Septic Alteration Plan Review

Block – 12201 AKA 83, Lot – 1 AKA 16&19

Jackson Township

SEPTIC ALTERATION PLAN

SEPTIC ALTERATION PLAN
 LOT 16&19 BLOCK 83
 LOT 1 BLOCK 12201
 JACKSON TOWNSHIP
 OCEAN COUNTY, NEW JERSEY

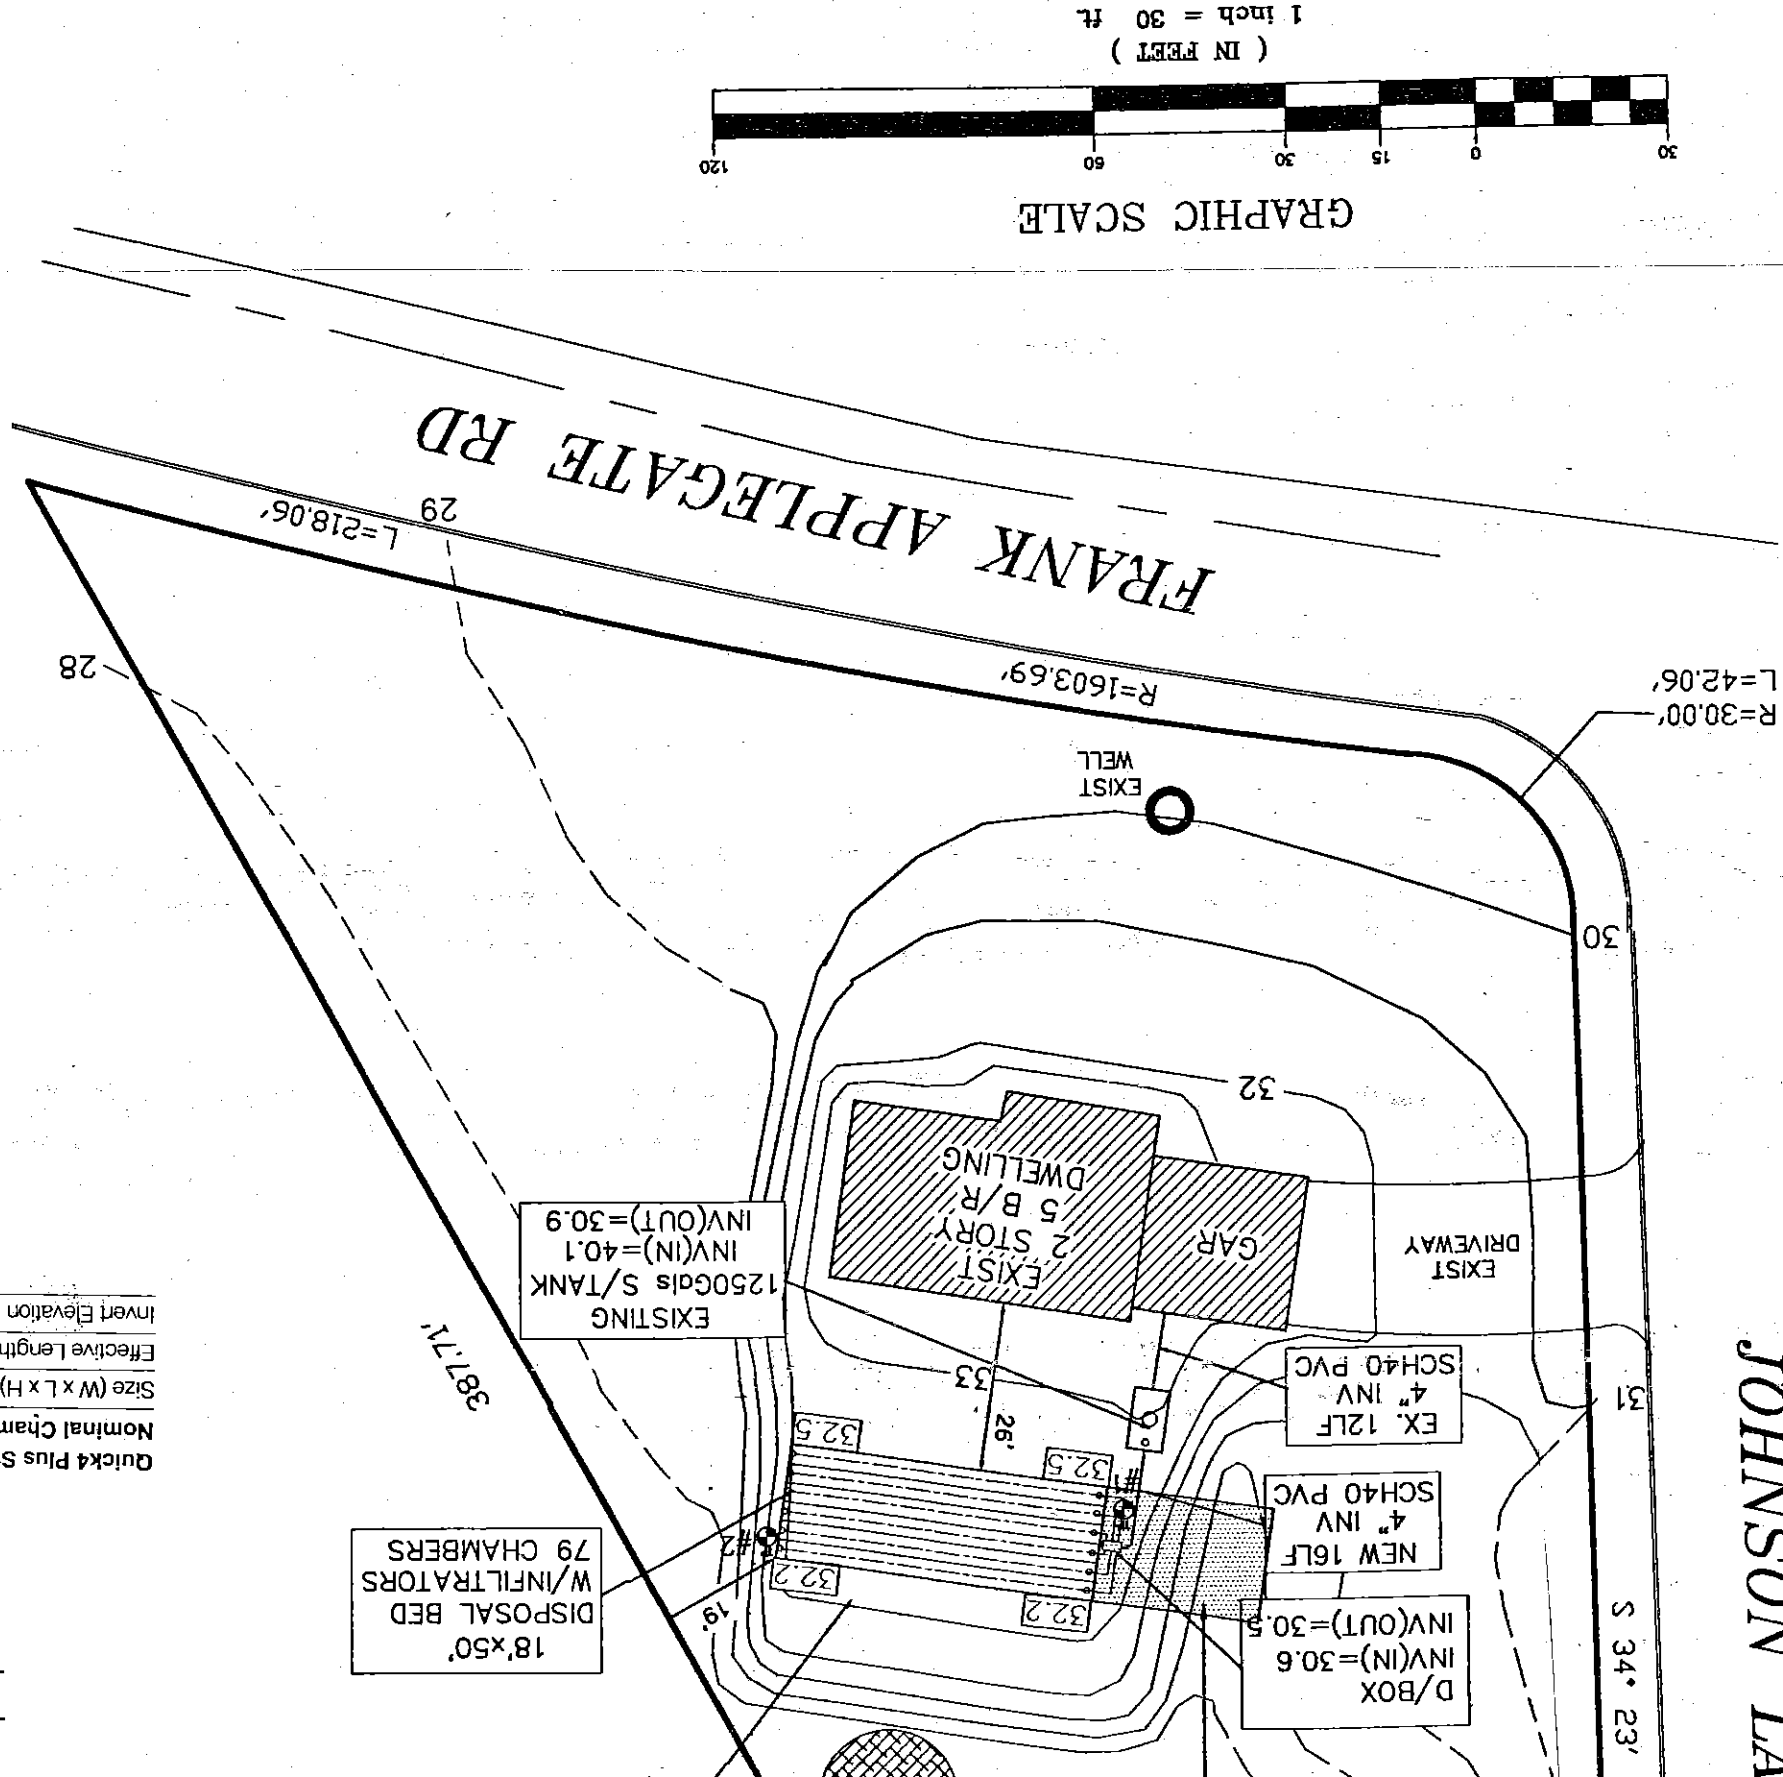
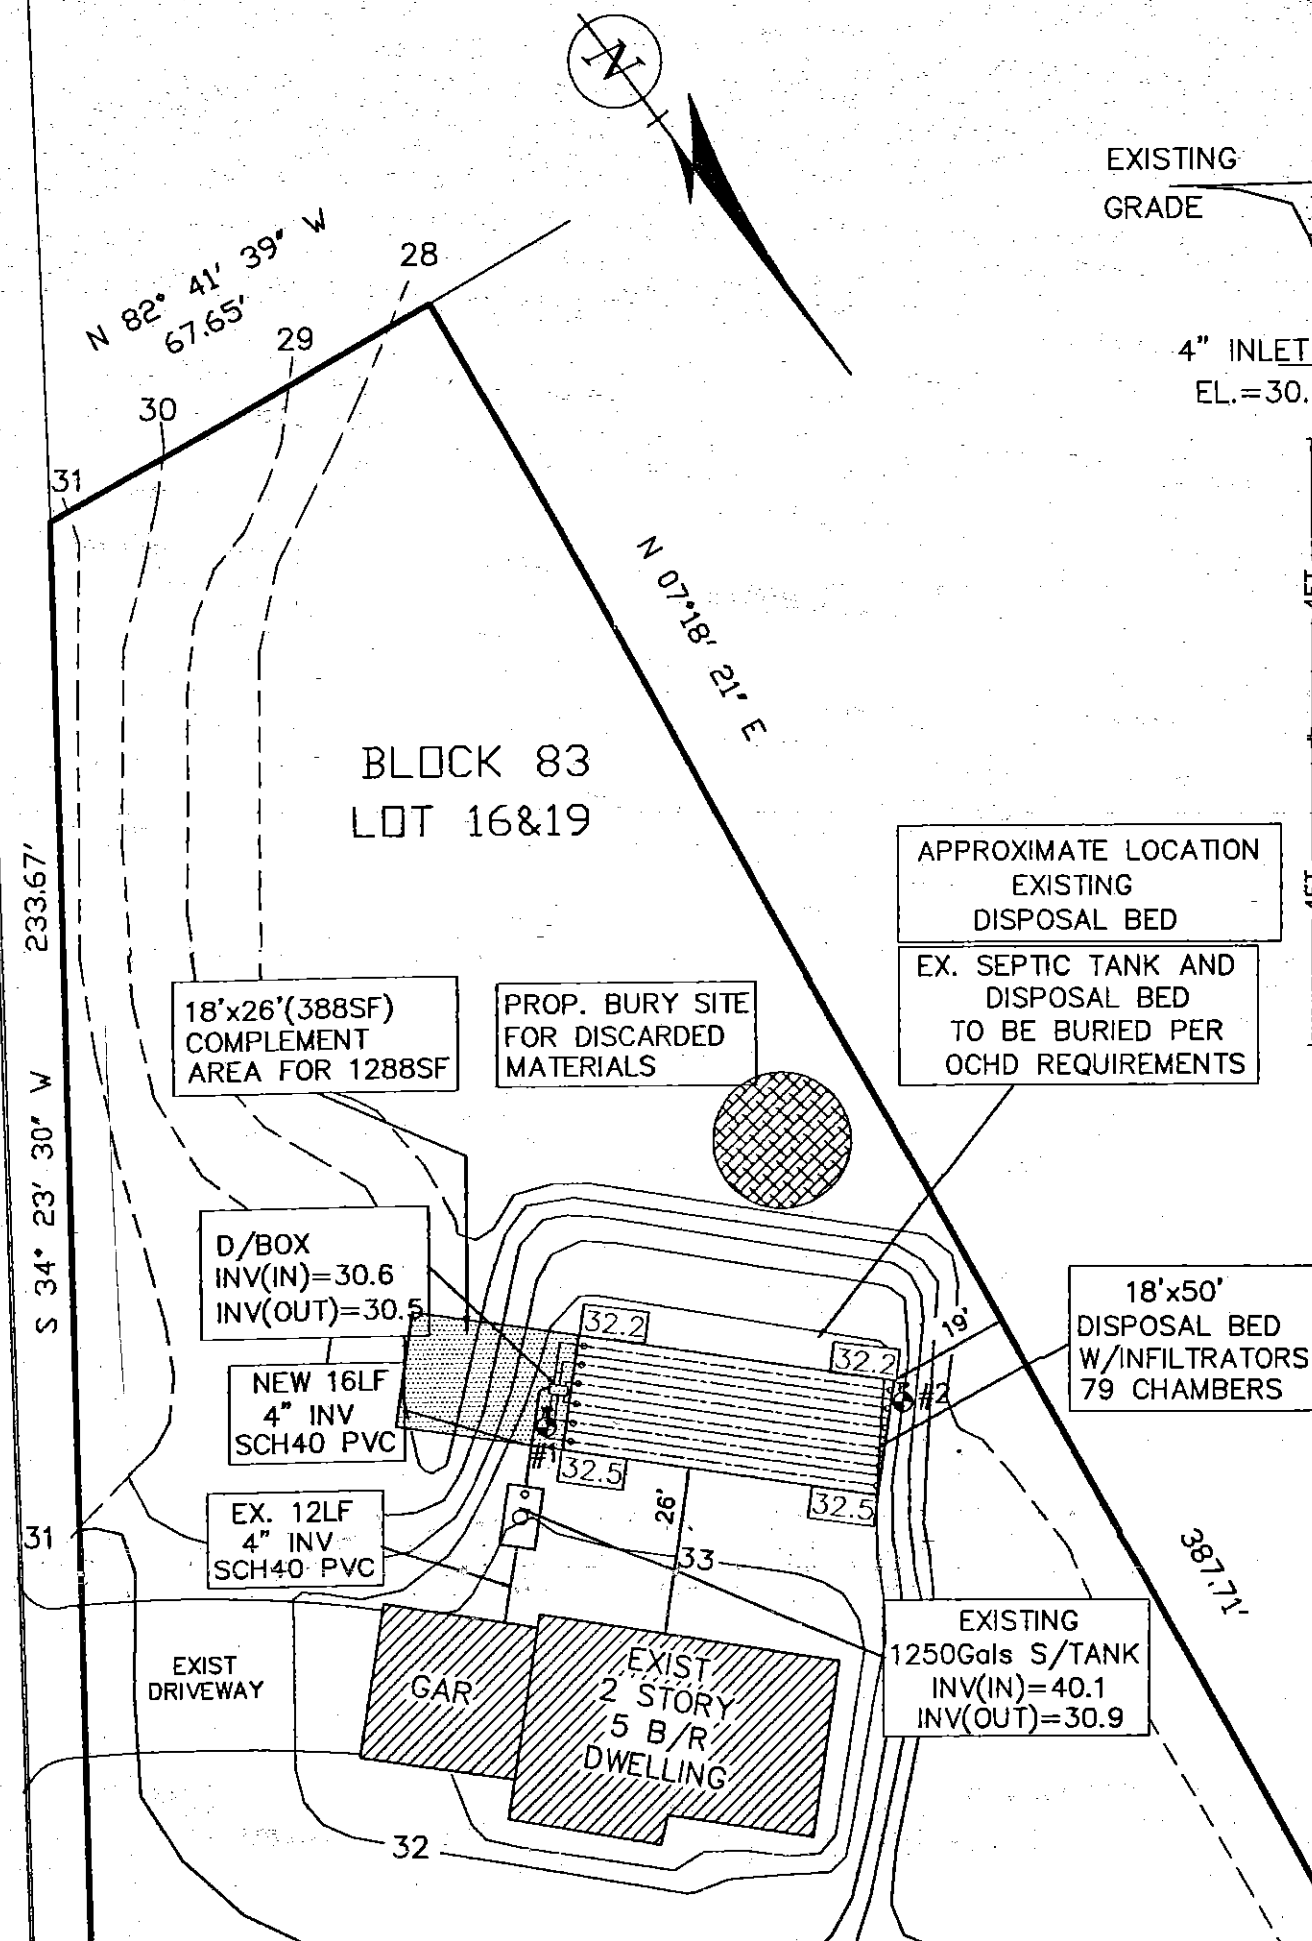
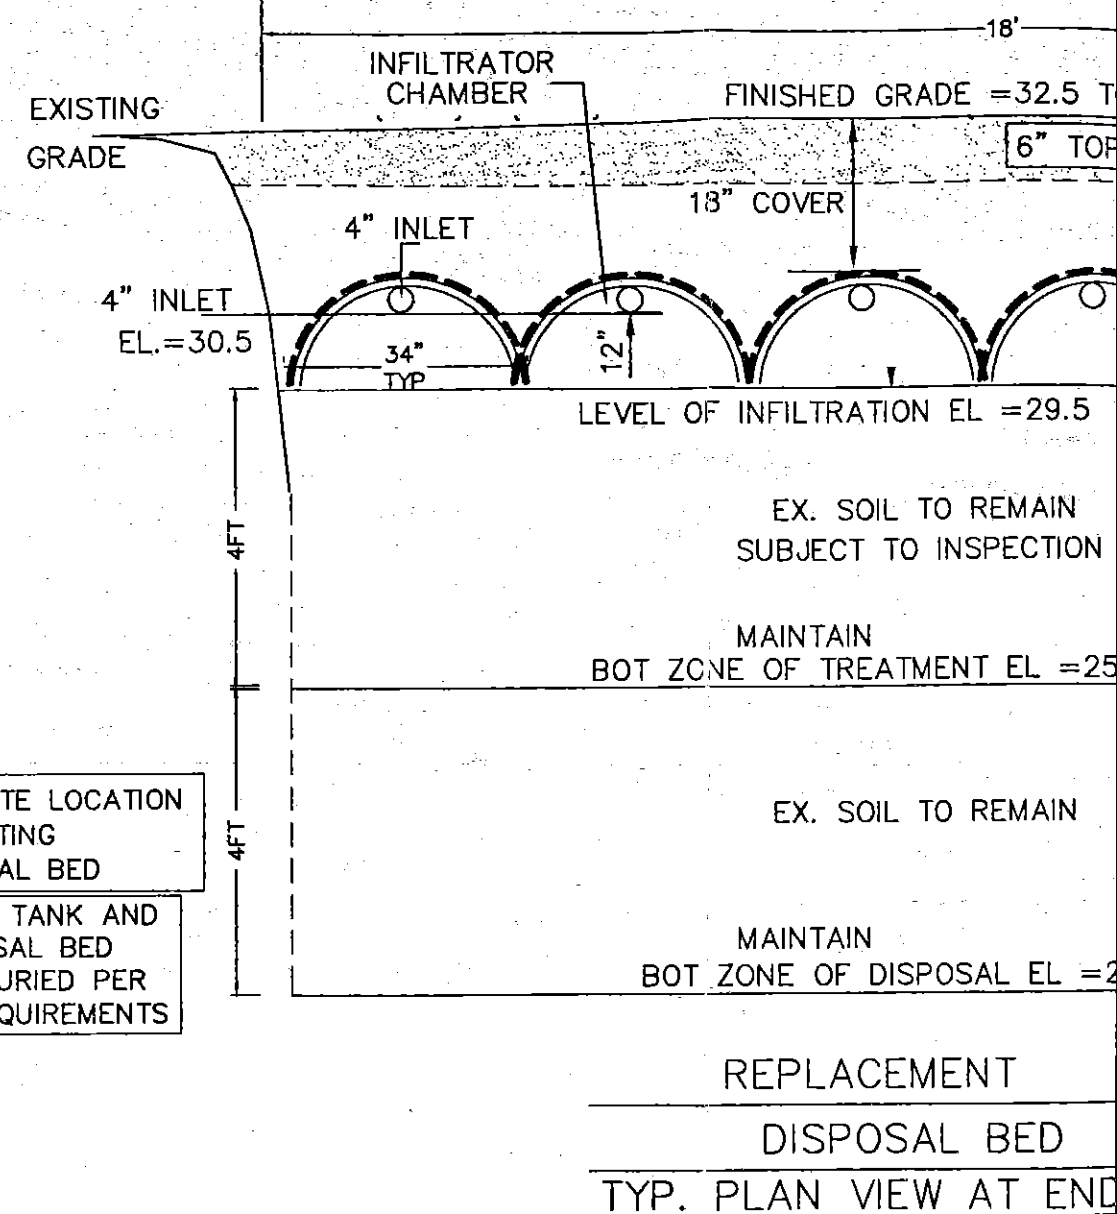
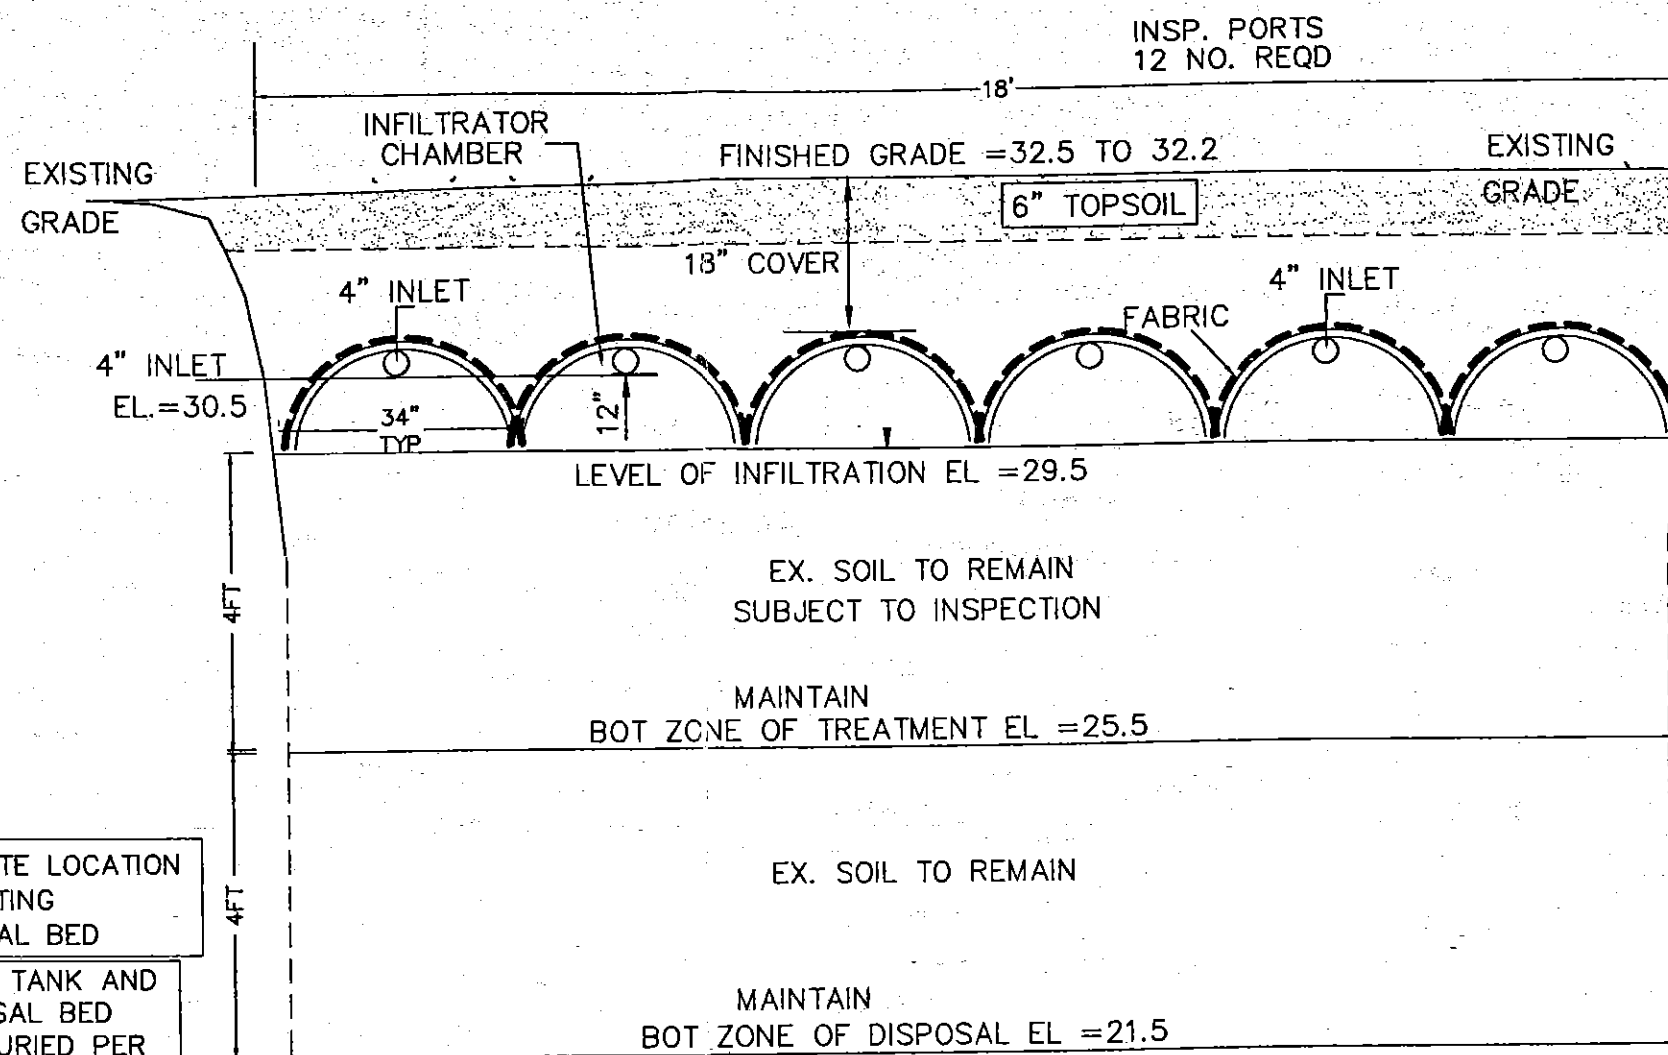
7:9A - 5.1 - Soil data required with application.

7:9A - 3.5(c) Please include a copy of TWA # 04-3487-4SG with your application. This Guidance document indicates the requirements of a reduced sized chamber system.

The site plan must delineate a disposal area sized at 100% of that which is required by Table 10.2(b) 10.2(b) or Table 10.2(c), for example.

REV-1(12-4-15) REVISED PER OCHD REVIEW LR
